ADDENDUM NO. [1] Date: April 1, 2022

**RE: Physical Plant Renovation
 Western Technical College
 505 9th Street North
 La Crosse, Wisconsin
 HSR Project 21065**

**FROM: HSR Associates, Inc
 100 Milwaukee Street
 La Crosse, WI 54603
 (608) 784-1830**

G002

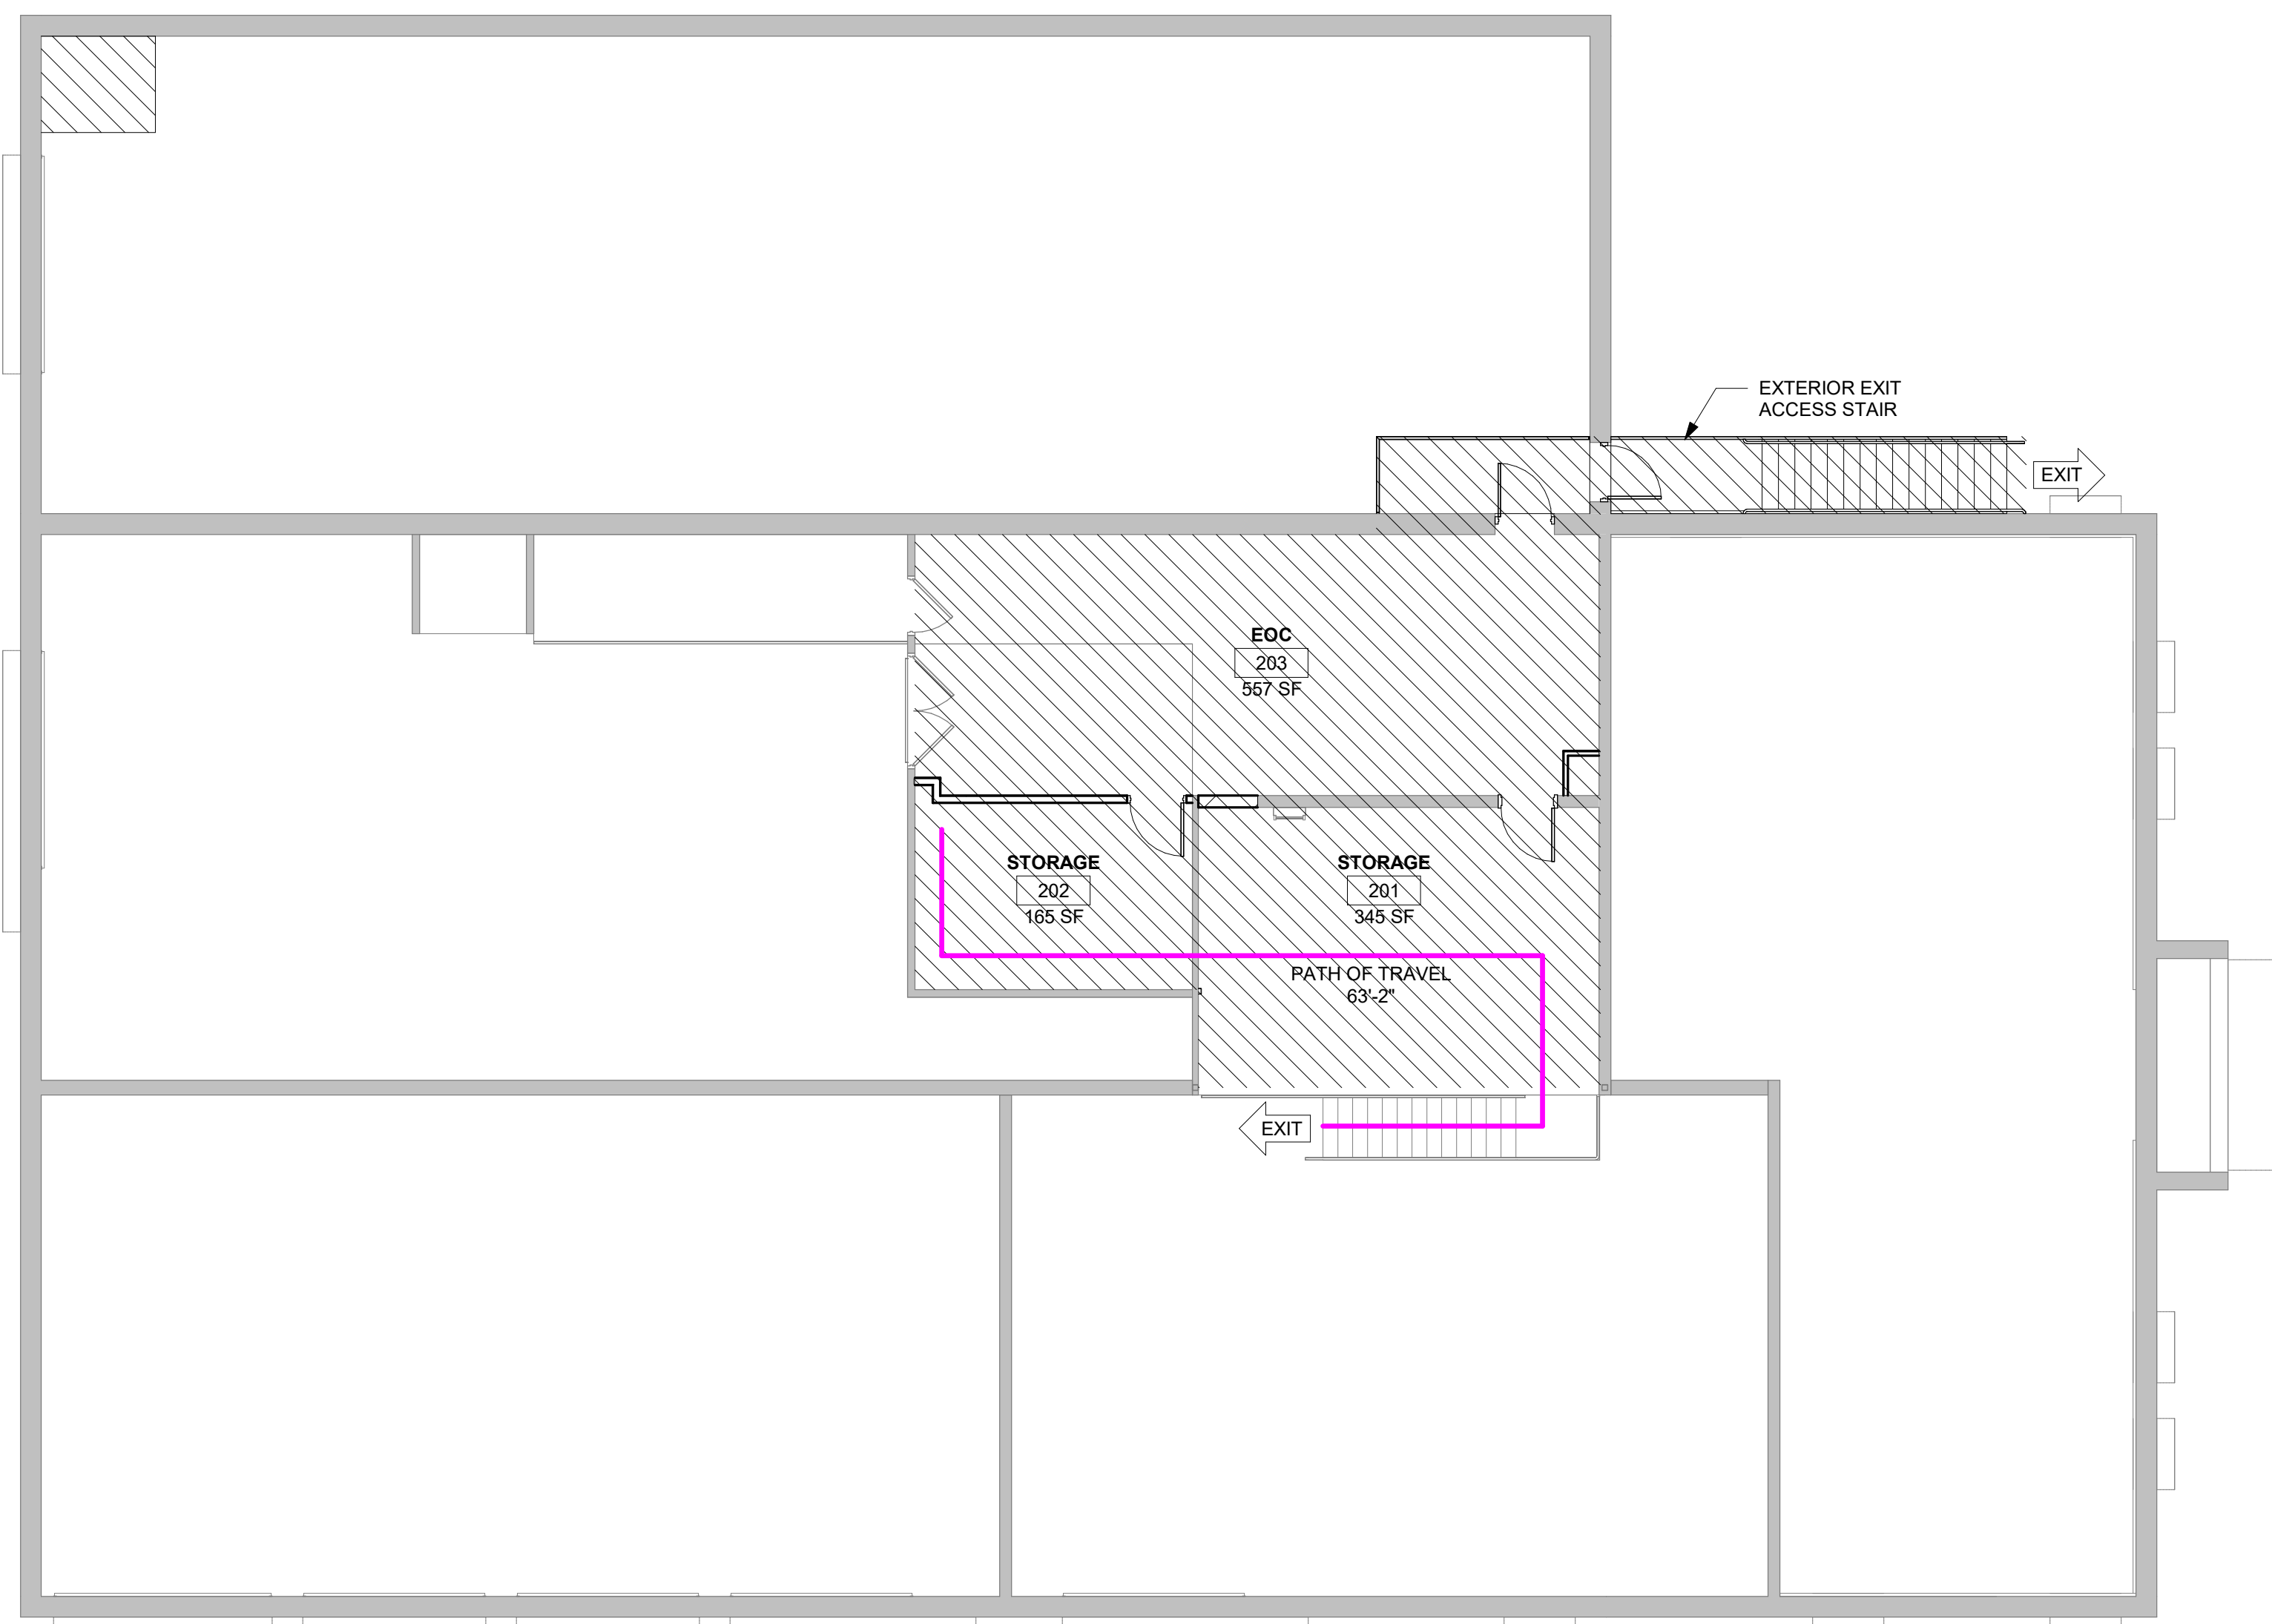
5. Sheet G002 LIFE SAFETY PLANS
 - a. See 30"x42" sheet attached hereto.
 - b. Fire extinguishers updated to existing.

A090

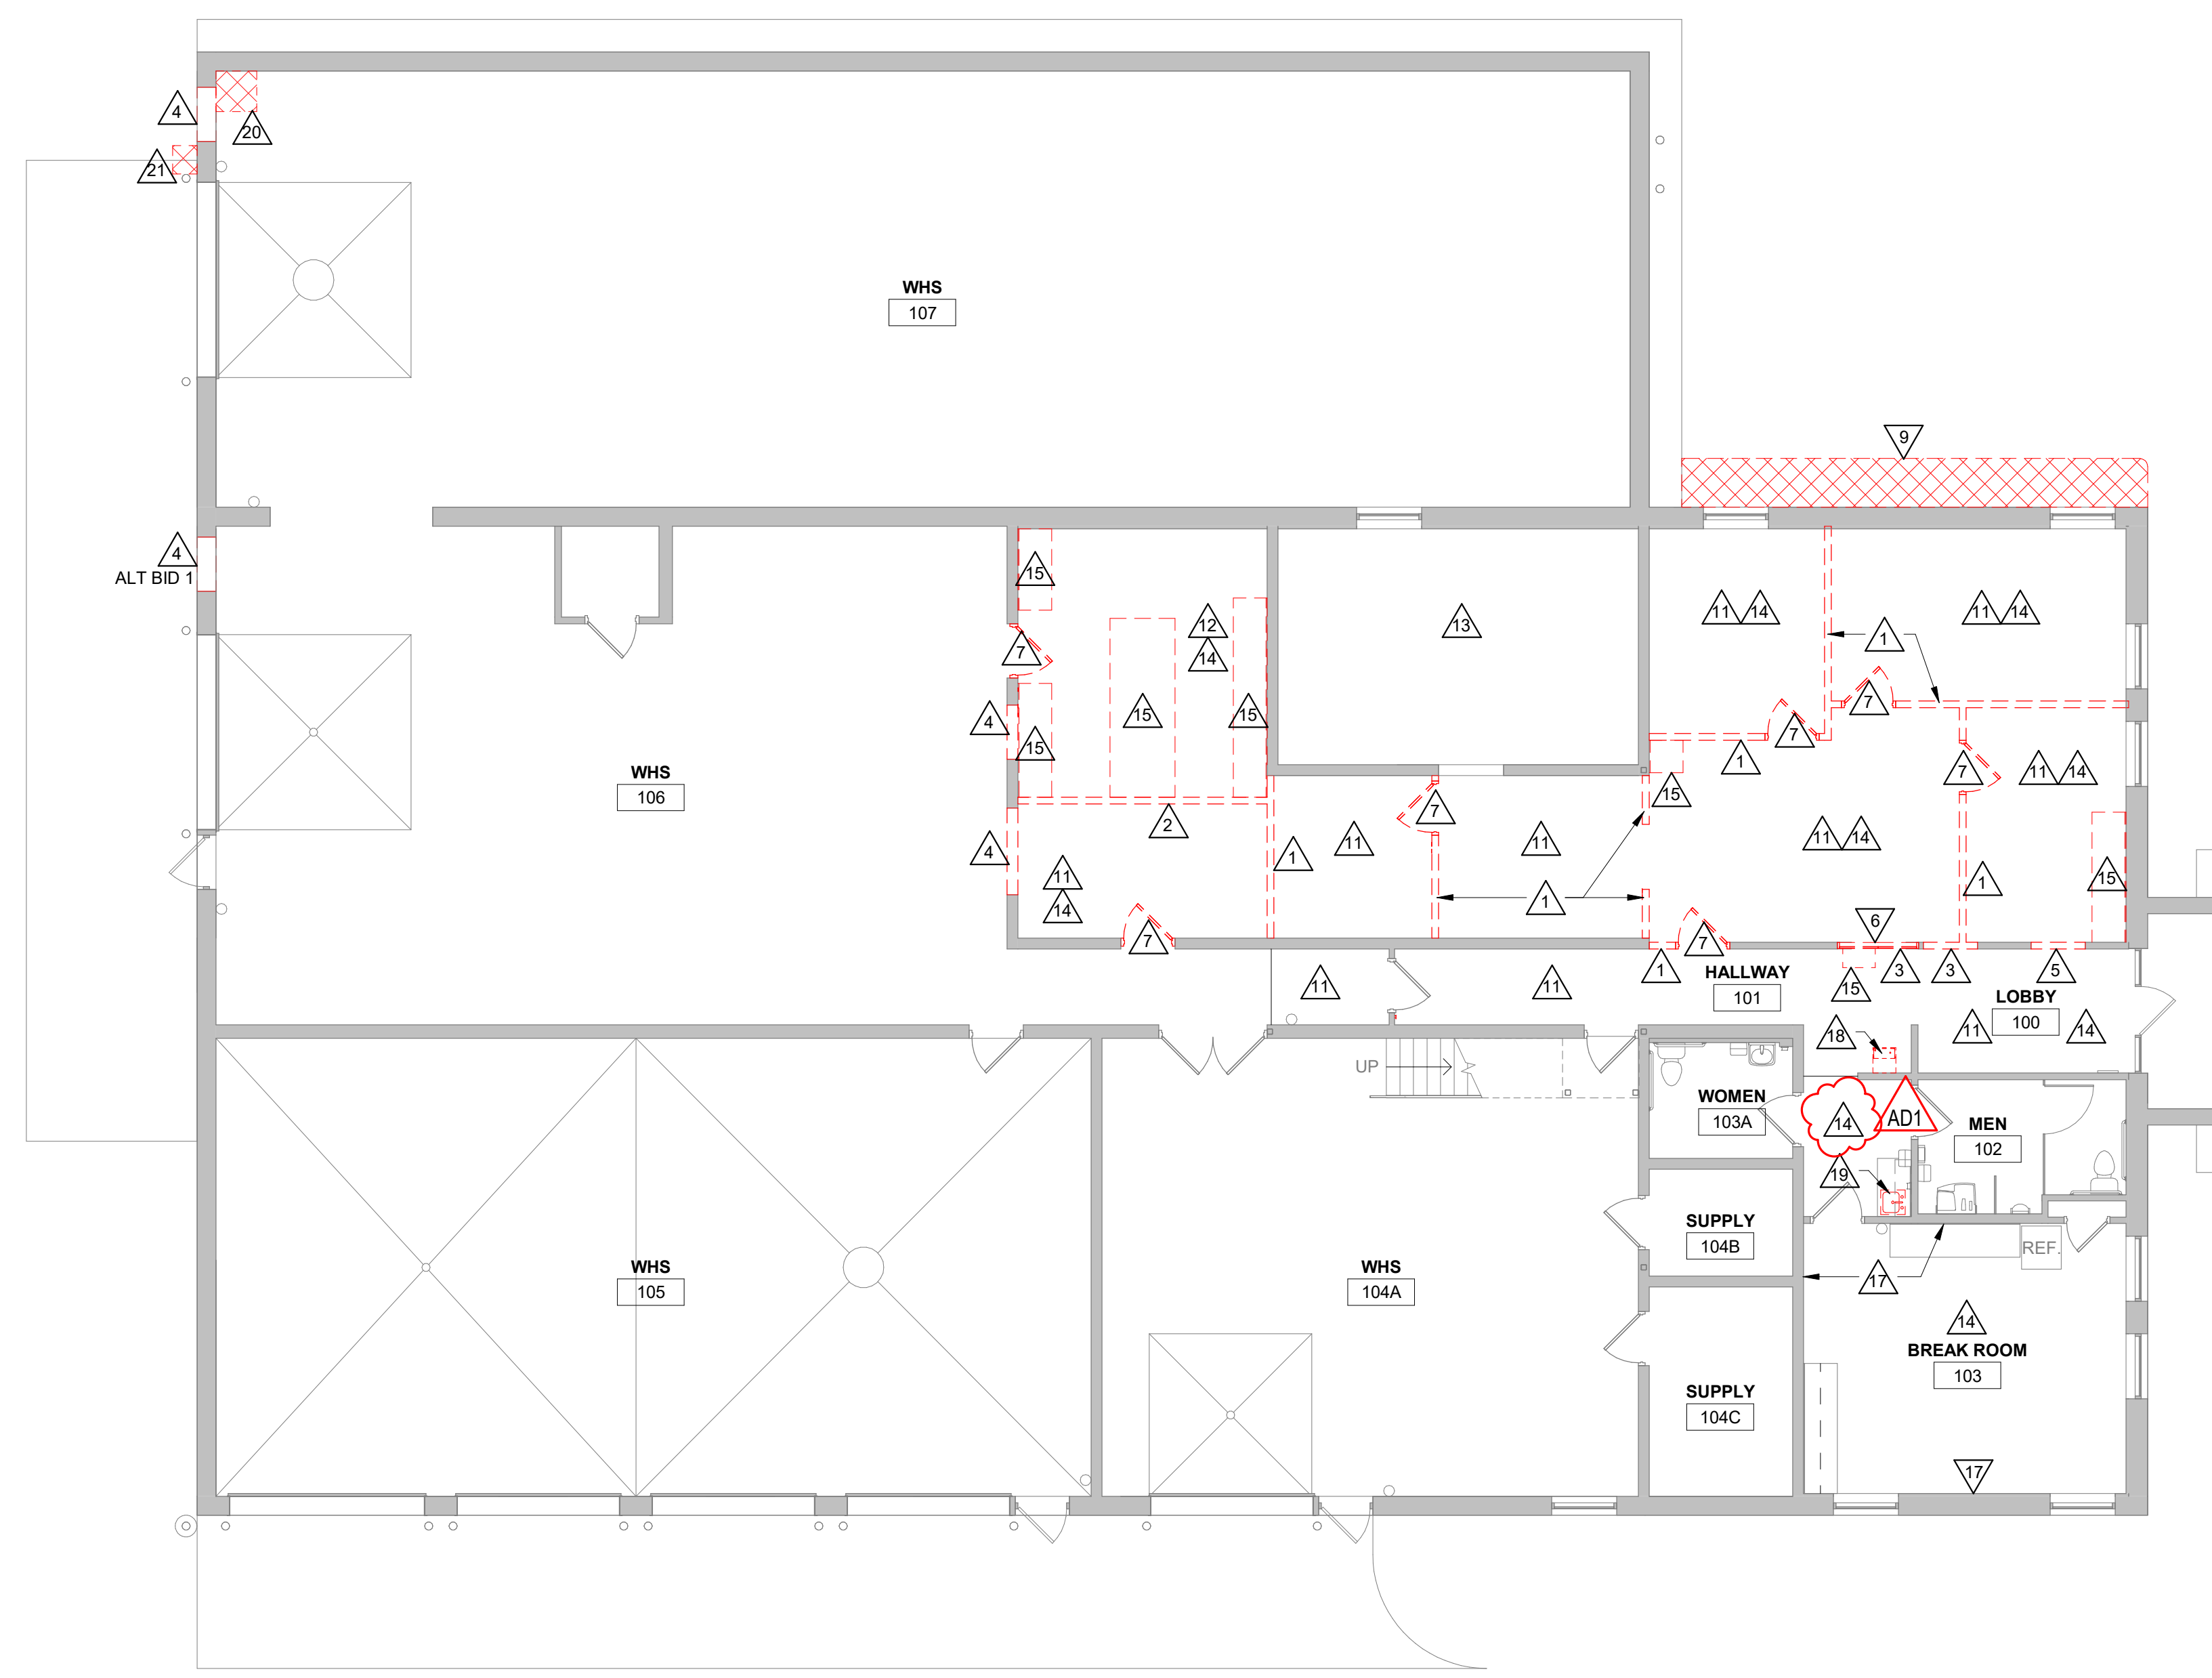
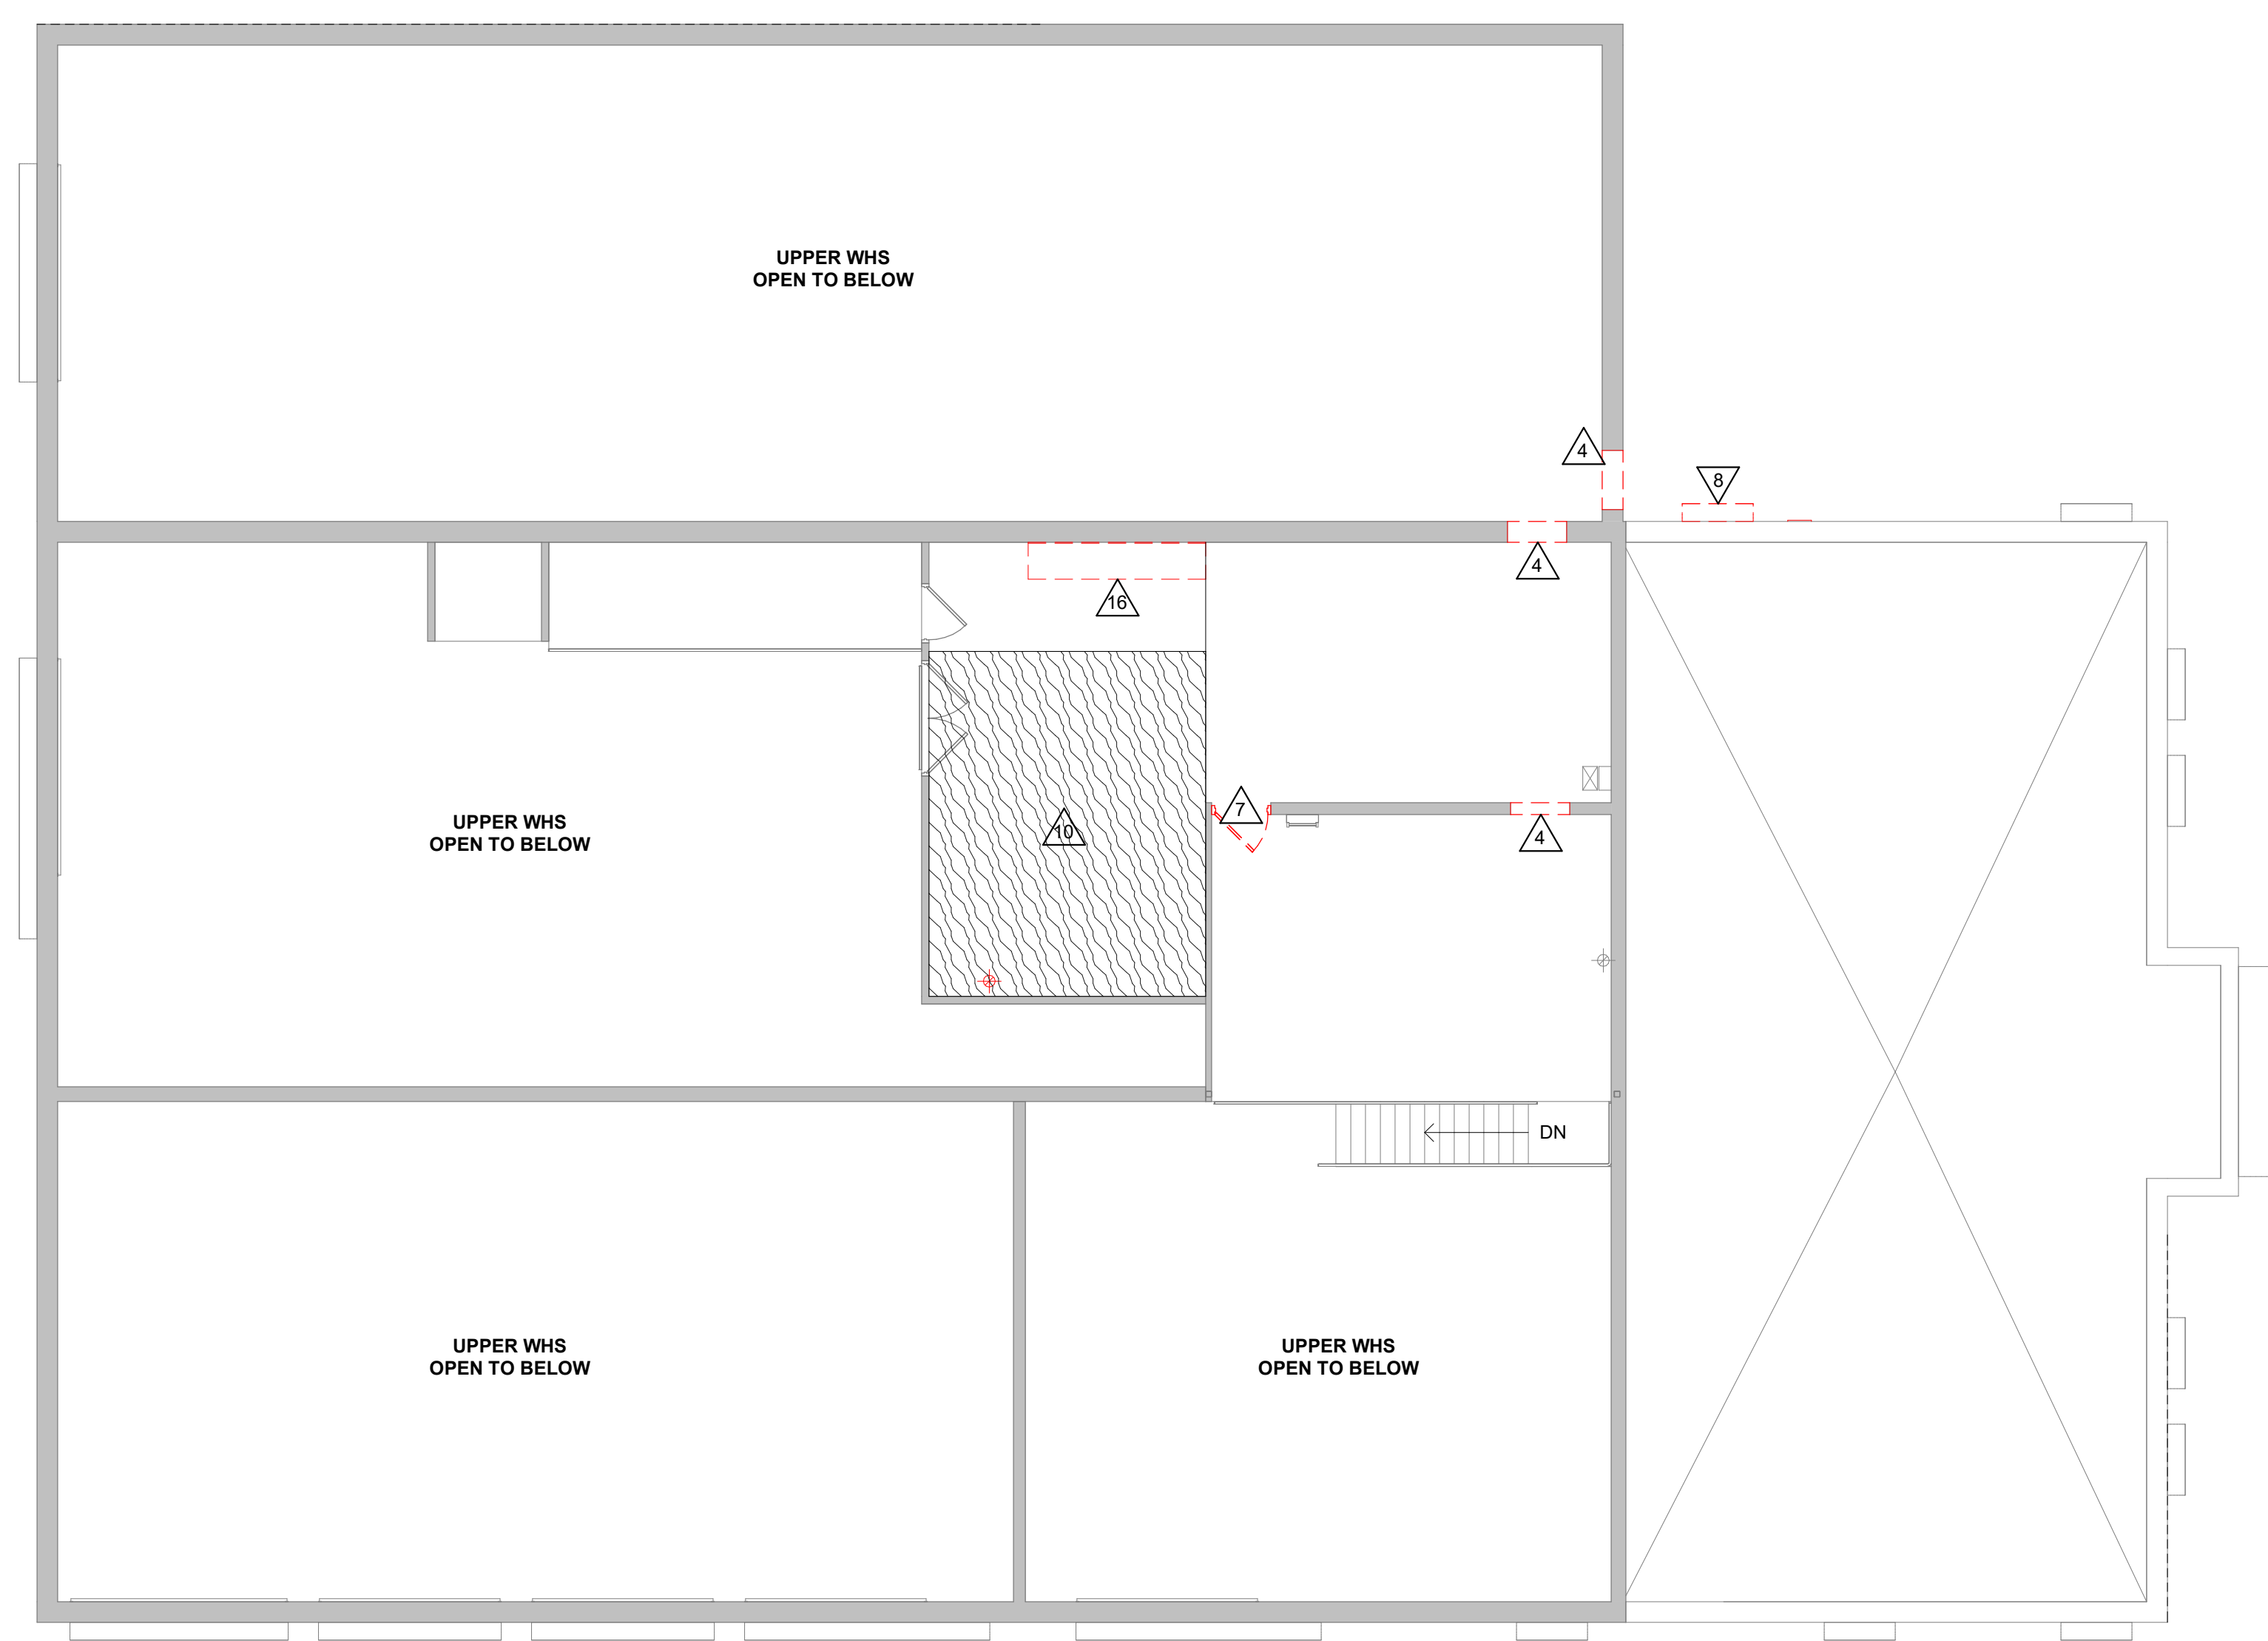
6. Sheet A090 DEMOLITION PLANS
 - a. See 30"x42" sheet attached hereto.
 - b. 1/A090: Keynote 14 added.
